Arne Anselm
Water Quality Manager
Ventura County Watershed Protection District

RE: Ventura County Technical Guidance Manual Comments

Camp Pendleton – Chambermaxx Infiltration

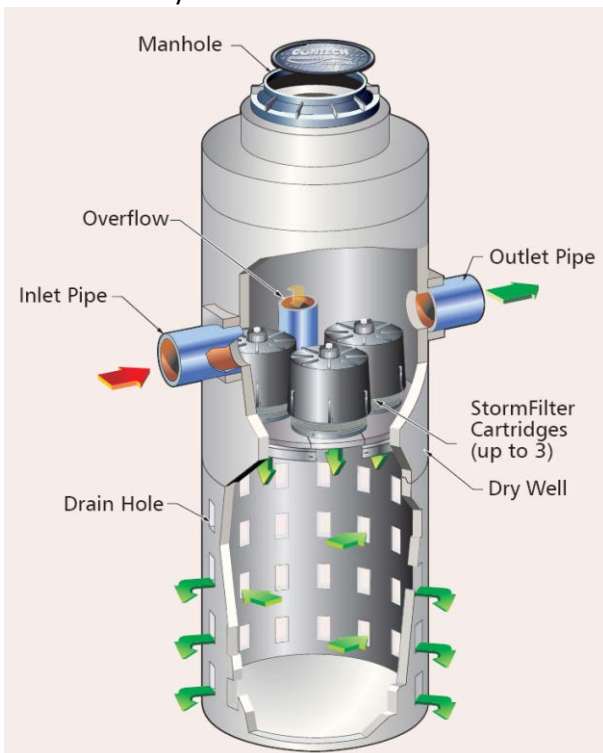
Both the CON/SPAN and StormTrap photos on page 6-73 are detention designs with a solid floor. An infiltration design would have concrete strip footings with a gravel floor. A sample CON/SPAN photo is attached to this letter.
